ExxonMobil Chemical Company

**Response to June 29, 2012
Completeness Determination Letter
Baytown Olefins Plant
Ethylene Expansion Unit**

ExxonMobil Response to EPA Completeness Comments Application for Greenhouse Gas Prevention of Significant Deterioration Permit ExxonMobil Chemical Company – Baytown Olefins Plant (BOP)

FIGURE 2-1
Block Flow Diagram
ExxonMobil Chemical Company
Ethylene Expansion Project

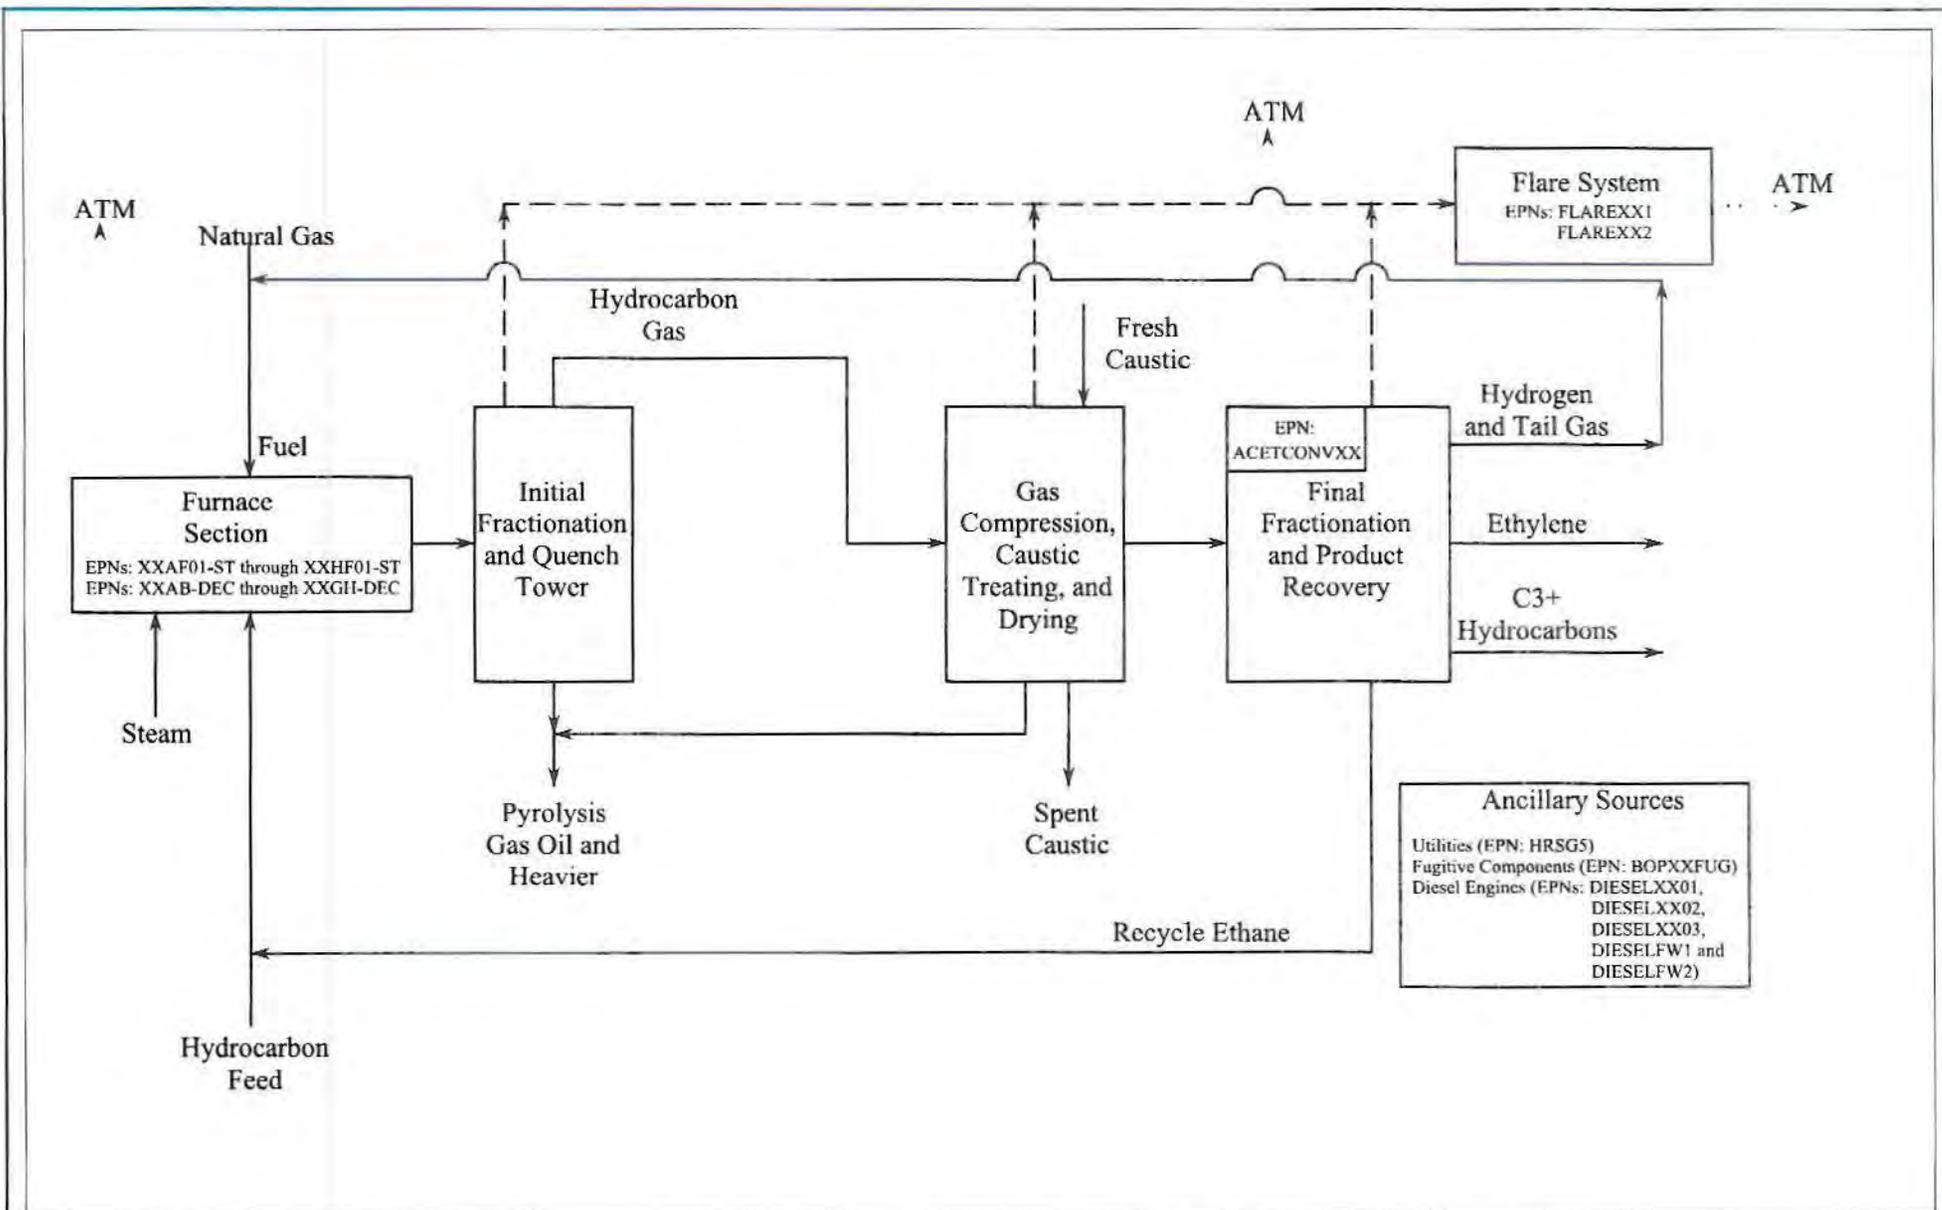
2. Please supplement the process flow diagram by identifying all emission control points for GHG emissions, include the emission control point identification numbers.

See Attachment 2 to this letter for the revised process flow diagram that includes emission control points.
